# ADA Curb Ramp New Construction Inspection Form (Parallel)

Main	24952.54			Wascoe	See <a href="https://www.oregon.gov/odot/Engineering/Documents_RoadwayEng/ADA_ExhibitA.pdf">https://www.oregon.gov/odot/Engineering/Documents_RoadwayEng/ADA_ExhibitA.pdf</a> for more corner styles. Use Washington County corner numbering system.
North-South Road Name	Project No.	Sheet No.	Intersection No.	East-West Road Name	
<b>Calibration Date</b> 10/8/2024 (mm/dd/yy)

PARALLEL RAMP (PL)

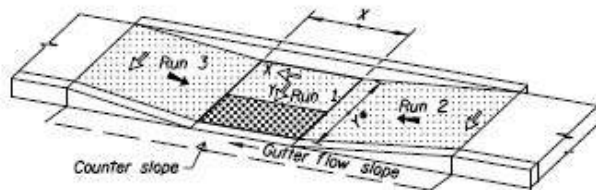
RAMP RUN 1	Pass	Fail
Running Slope 1	2.8 ≤ 2.0% <input type="checkbox"/> > 2.0% <input checked="" type="checkbox"/>	
Cross Slope 1	2.0 ≤ 2.0% <input checked="" type="checkbox"/> > 2.0% <input type="checkbox"/>	
Detectable Warning	Y Y <input checked="" type="checkbox"/> N <input type="checkbox"/>	
Lip Height	0 ≤ 1/4" <input type="checkbox"/> > 1/4" <input type="checkbox"/>	
Gutter Flow Slope	0.8 ≤ * <input checked="" type="checkbox"/> > * <input type="checkbox"/>	
Curb Running Slope (avg)	<input type="checkbox"/> 1.52 ≤ 8.3% <input type="checkbox"/> > 8.3% <input type="checkbox"/>	
Counter Slope (+/-)*2	7.4 ≤  5.0%  <input checked="" type="checkbox"/> >  5.0%  <input type="checkbox"/>	
Det. warning full width of ramp	Y Y <input checked="" type="checkbox"/> N <input type="checkbox"/>

RAMP RUN 3	Pass	Fail
Running Slope 3	<input type="checkbox"/> ≤ 8.3% <input type="checkbox"/> > 8.3% <input type="checkbox"/>	
Length 3	7.35	
Cross Slope 3	3.5 ≤ 2.0% <input type="checkbox"/> > 2.0% <input checked="" type="checkbox"/>

IITD gt2. Rr2 is grass. No end of walk barricade.
